Final Report

Analysis for the Dominion Virginia Power 1A Proposal

Prepared for
PJM Interconnection

December 2014

FIGURE B
Typical Dead Tank Breaker Configuration

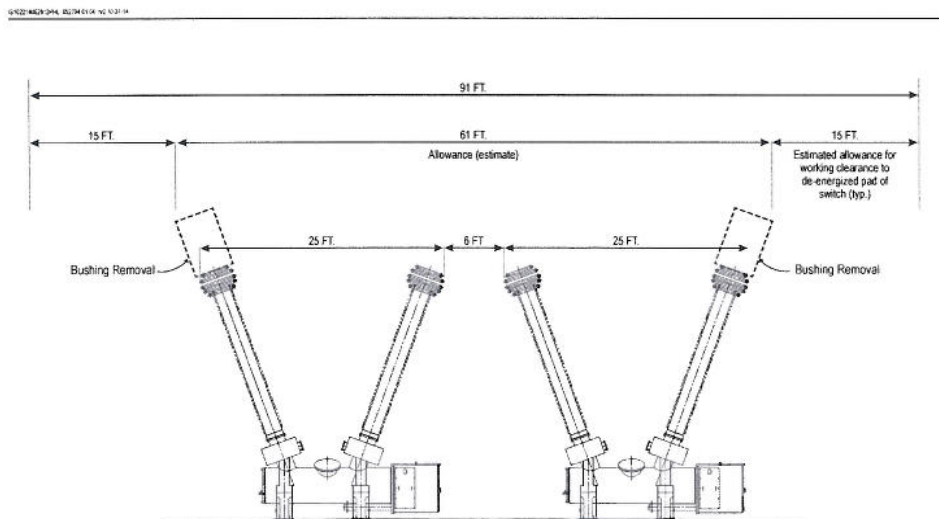
Figure B reflects a back-to-back breaker installation that portrays a typical breaker dimension of 25 feet between the outside of the breaker terminal corona control hardware. The working clearances between the breaker and the adjoining switch (not shown) are allowed at 15 feet, plus a 2.5-foot allowance on either end for bushing removal, and 6 feet of working space in between the breakers. The total estimated dimension allowed for the installation is 91 feet between the terminal pads of the adjoining switches.

The bushing removal space is that space required for removal of a bushing, should a bushing become damaged or the breaker require replacement. This space must be allowed in installations. In this instance this added bushing removal space requires 2.5 feet for each end bushing, which adds 5 feet overall.
